6.2 Containment Systems

The information in this section of the reference ABWR DCD, including all subsections, tables, and figures, is incorporated by reference with the following departures and supplements.

STD DEP 6.2-2 (~~Tables 6.2-1, 6.2-2 and 6.2-2a~~ Tables 6.2-1 and 6.2-2, Figures 6.2-2, 6.2-3, 6.2-4, 6.2-5, 6.2-6, 6.2-7, 6.2-9, 6.2-10, 6.2-11, 6.2-12, 6.2-13, 6.2-14 and 6.2-15)

Figure 6.2-3 Feedwater Line Break Flow—Feedwater System Side of Break

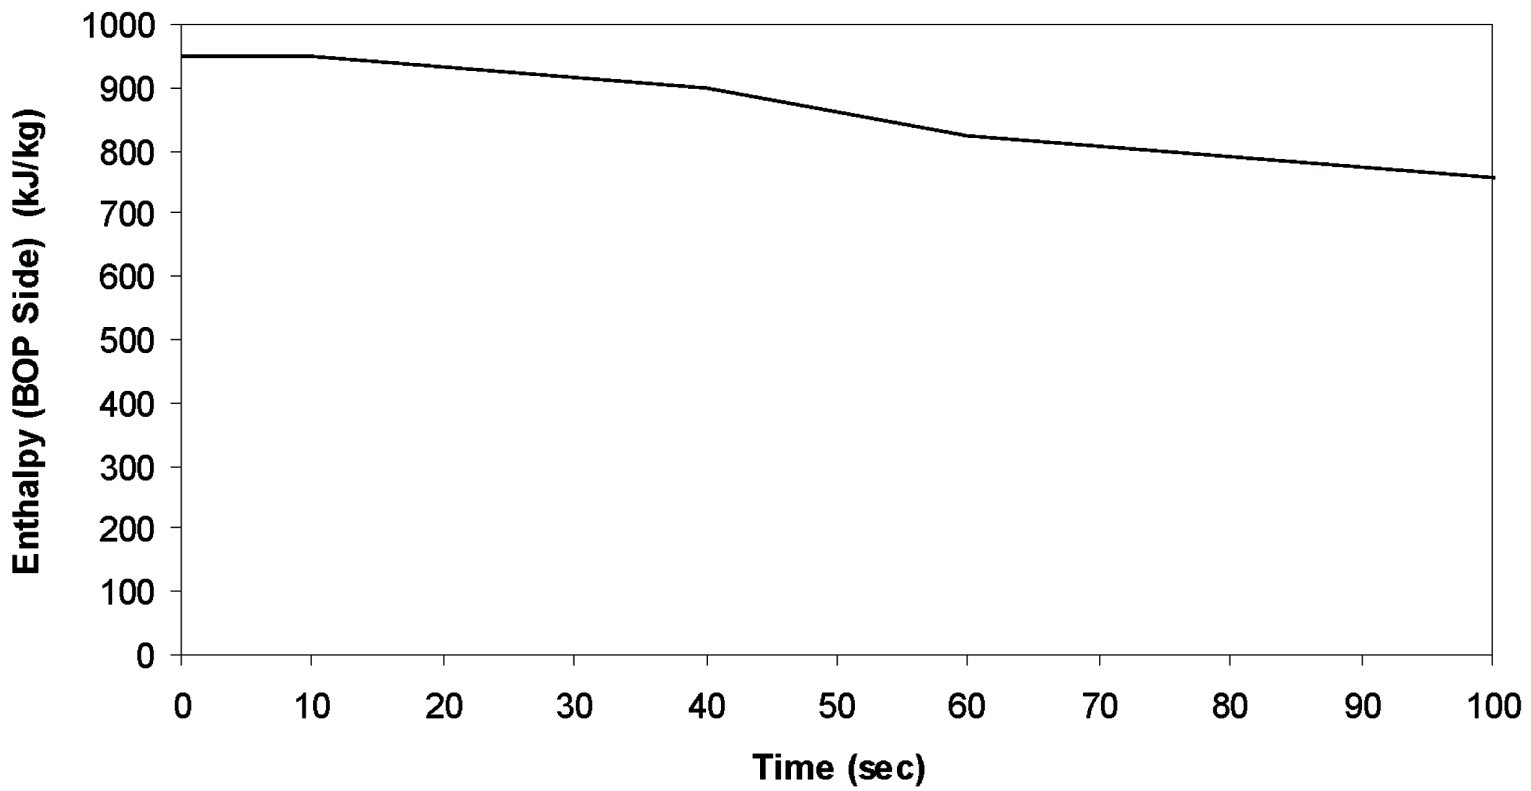
~~The maximum possible feedwater flow rate was calculated to be 164% of nuclear boiler rated (NBR), based on the response of the feedwater pumps to an instantaneous loss of discharge pressure. Since the Feedwater Control System will respond to decreasing RPV water level by demanding increased feedwater flow, and there is no FWLB sensor in the design, this maximum feedwater flow was conservatively assumed to continue for 120 seconds (Figure 6.2-3). This is very conservative because:~~

In order to provide further assurance of conservatism, FWLB mitigation is added to the ABWR design. The system is described in Section 7.3.1.1.2. The specific enthalpy time history, assuming the break flow of Figure 6.2-3, is shown in Figure 6.2-4. Initial reactor power is assumed to be 102% NBR.

Figure 6.2-6 Pressure Response of the Primary Containment for Feedwater Line Break

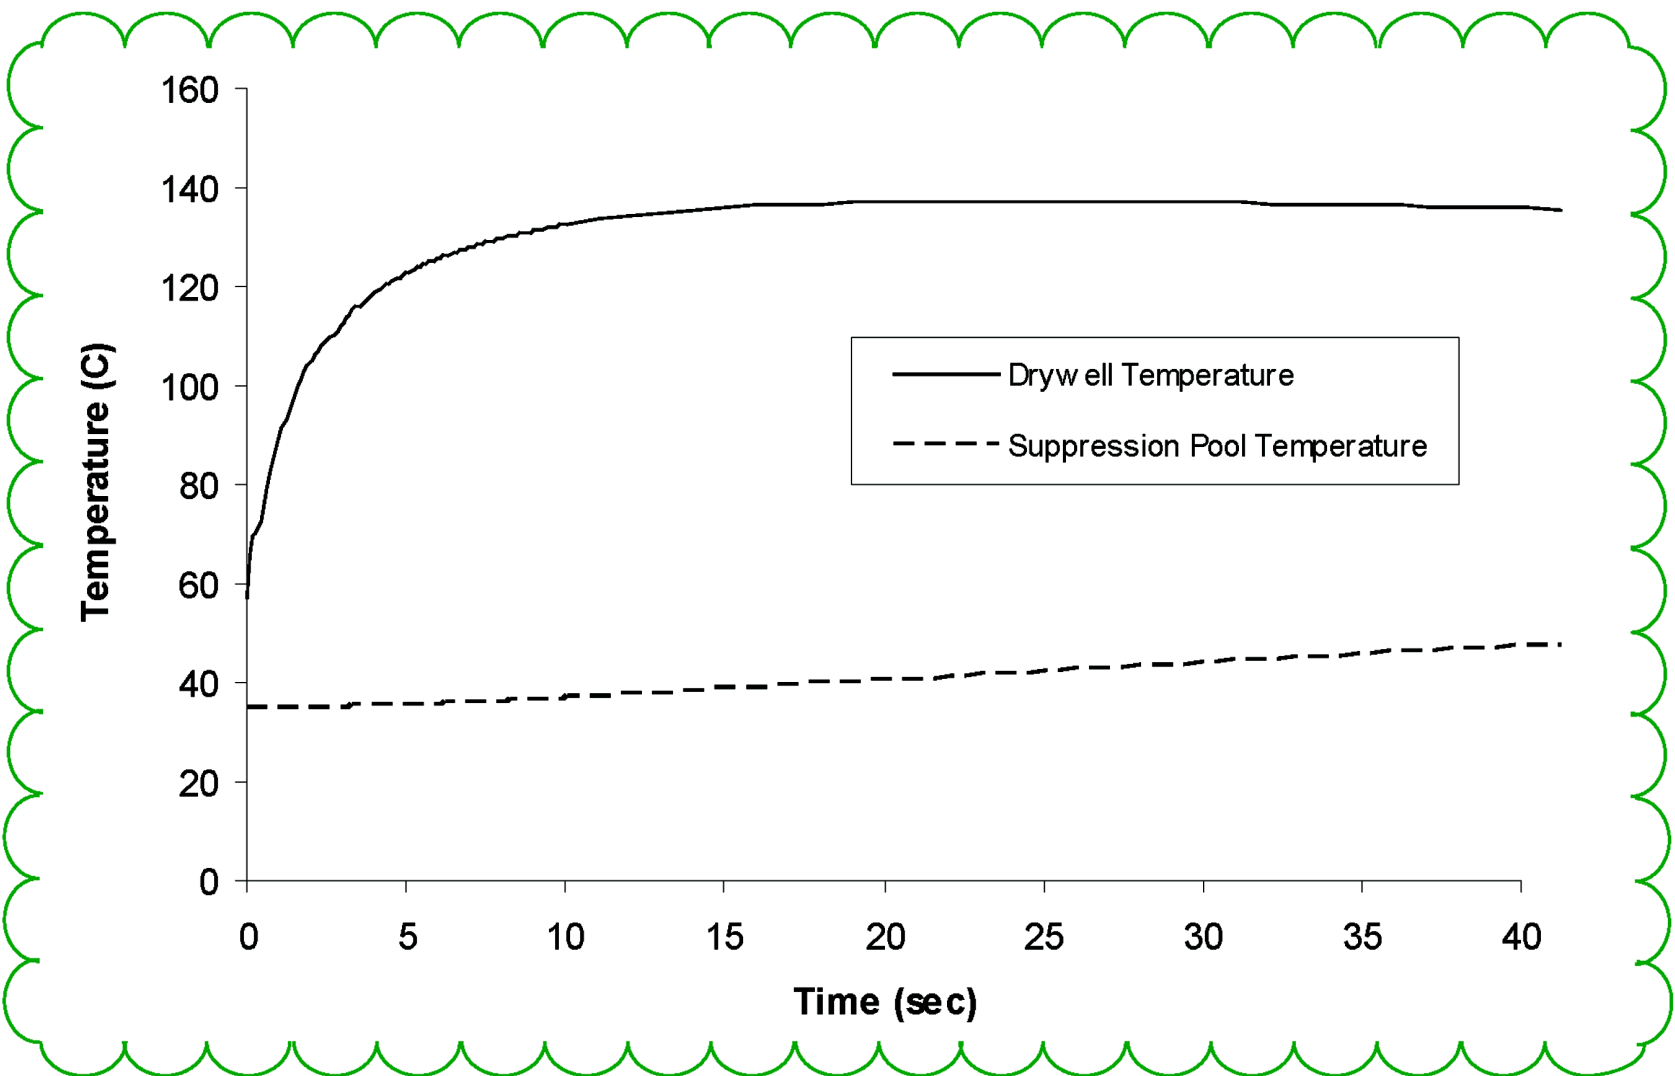
The calculated containment pressure and temperature responses for a feedwater line break are shown in Figures 6.2-6 and 6.2-7, respectively. ~~The peak pressure (268.7 kPaG) and temperature (140°C) occur in the drywell. The containment design pressure of 309.9 kPaG is 115% of the peak pressure.~~

~~The short term pressure peak (268.7 kPaG) of Figure 6.2-6 is the peak pressure for the whole transient.~~ Figure 6.2-8 shows temperature time histories for the suppression pool, wetwell, and drywell temperatures. The peak pool temperature (96.9°C) is reached at 15,350 seconds (4.264 hours) and remains below the 97.2°C limit.

Figure 6.2-12 Pressure Time History for MSLB with Two Phase Blowdown Starting When the RPV Collapsed Level Reaches the Main Steam Nozzle

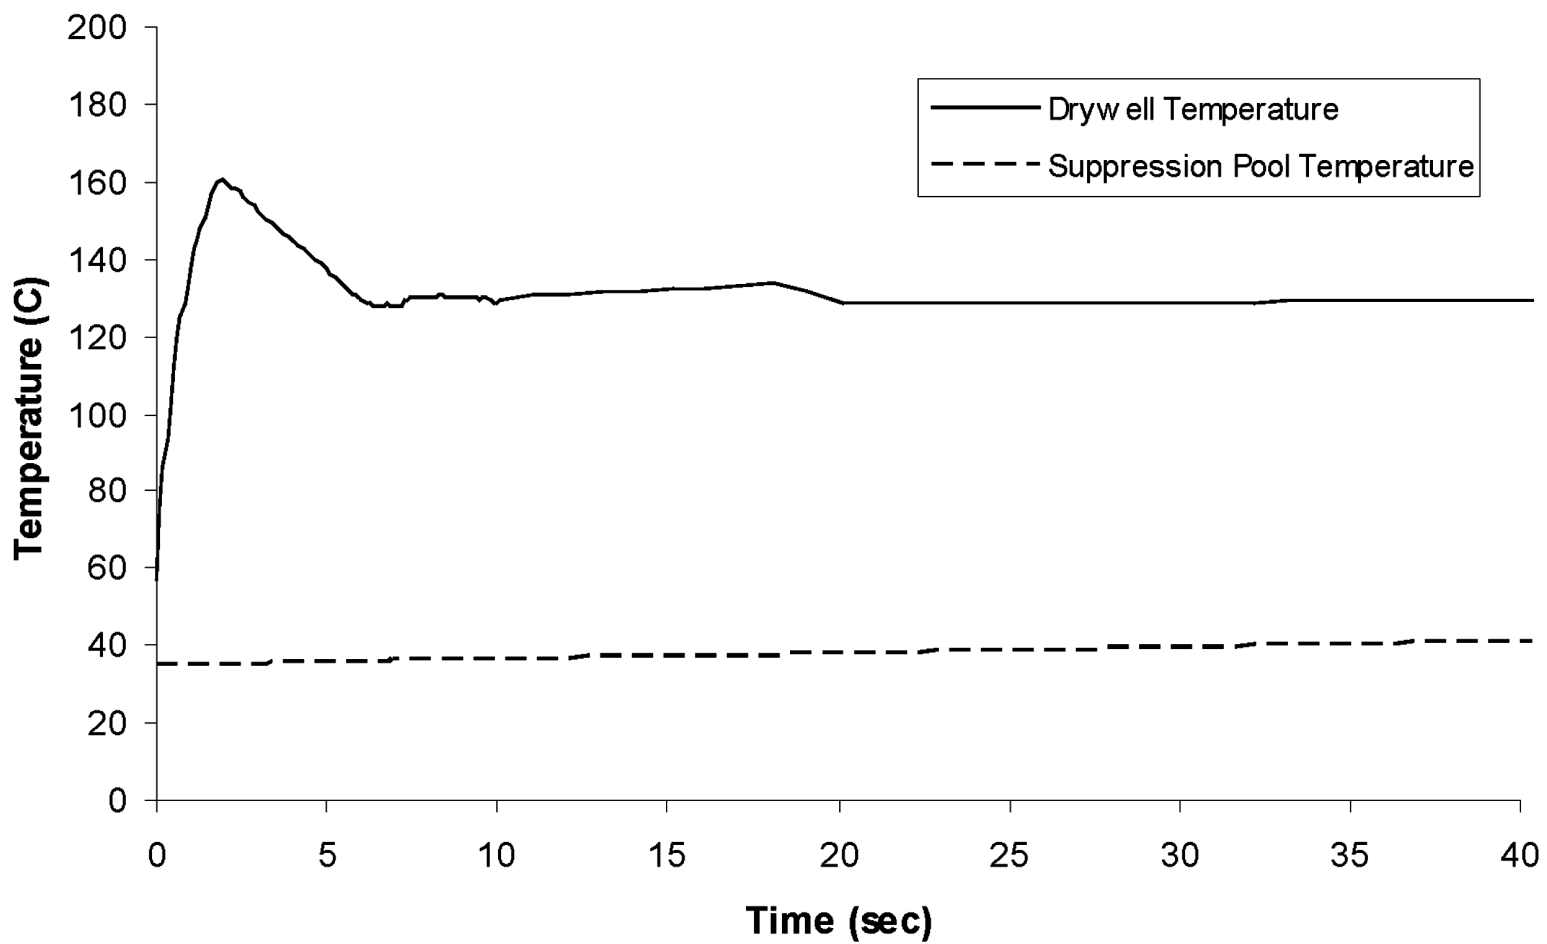
Figures 6.2-12 ~~through 6.2-15~~ and 6.2-13 show the pressure and temperature responses of the drywell and wetwell during the blowdown phase of the steamline break accident.

The maximum drywell temperature (161°C) is predicted to occur for the steamline break. The MSLB with two-phase blowdown starting when the RPV collapsed level is at the main steamline nozzle provides the highest peak drywell temperature. The peak drywell temperature is ~~169.7~~ 161°C, below the design value of 171.1°C, and is the limiting one as compared to the FWLB peak temperature. The peak drywell pressure for the MSLB remains below that for the FWLB, which becomes the most limiting. The peak drywell temperature and pressure is below the design temperature and pressure. The MSLB is the limiting event for peak drywell temperature. The FWLB is the most limiting for drywell pressure.
